**HISTORIC PRESERVATION BOARD
CITY OF PORTLAND, MAINE**

**PUBLIC HEARING
13 CARROLL STREET**

Application For: Certificate of Appropriateness for handicap ramp construction (After-the Fact Review)

Address: 13 Carroll Street

Floor Plan H.C. Ramp Detail

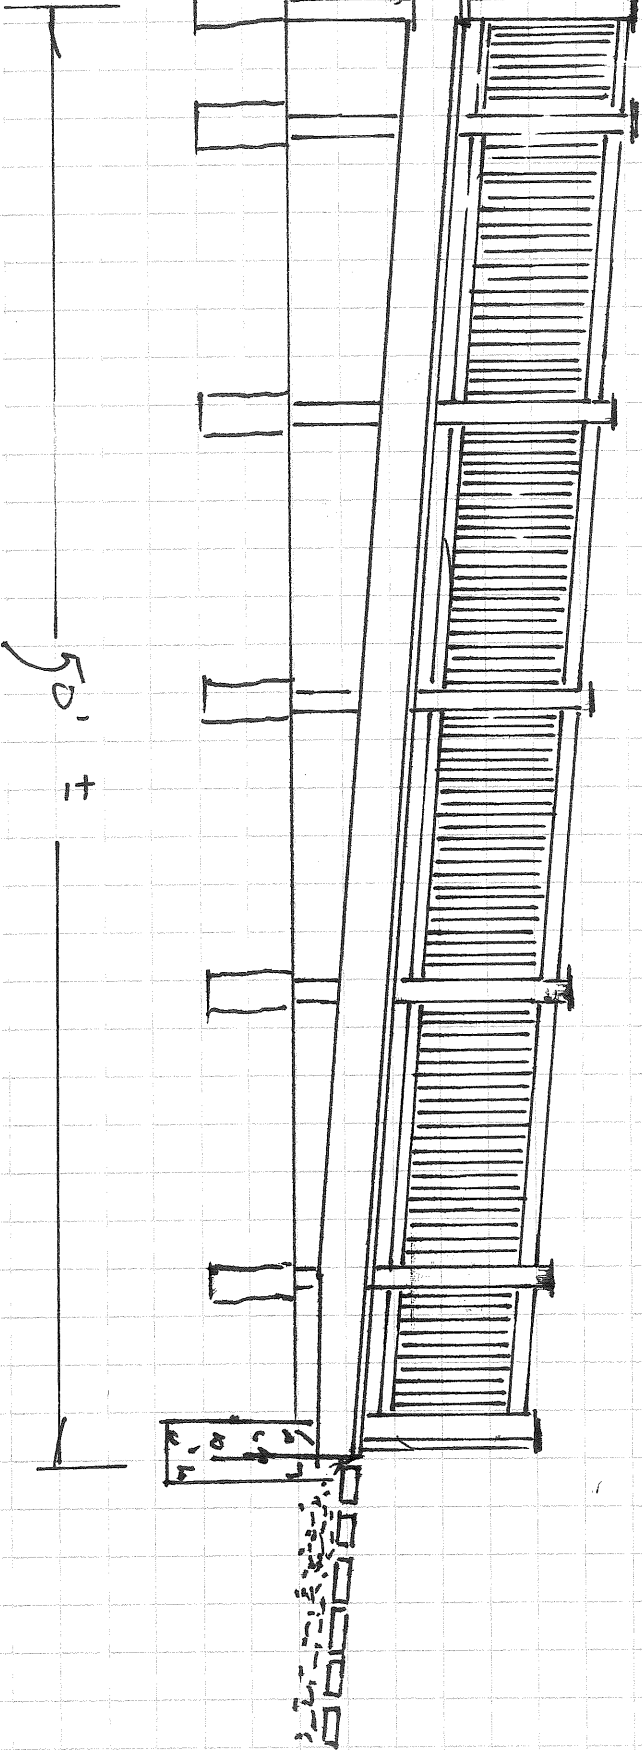
The project consists of a forty-eight foot long ramp which begins about eight feet back from the front corner of the building and continues around the back corner. The house sits 8'-10" from the side property line, requiring a Disability Variance for the four foot wide ramp. (The project has not yet been presented at Zoning Board of Appeals meeting.) The ramp flares slightly at the bottom, where the composite decking feathers nicely into the brick walk. A series of four basement windows has been protected with safety glass panels, which preserve the intact appearance. The windows are increasingly hidden by the ascending ramp towards the rear of the house. Pairs of Azek-sleeved and capped posts in a dark brown color will support a profiled rail and 1-3/8" square balusters of the same material. Skirting of square, lap-jointed, painted wood lattice will enclose the area below the ramp. At the rear of the house the ramp connects to a pre-existing, reconstructed rear deck that is not visible from Carroll Street.

The applicant describes the ramp as a temporary installation that can be removed when it is no longer needed, though solid construction and durable materials give it the appearance and solidity of a permanent structure. While there is no disguising that the ramp is appended to the side of the house to meet a modern-day need, the Board will no doubt consider whether the location, design and materials are compatible with the subject building and the surrounding context.
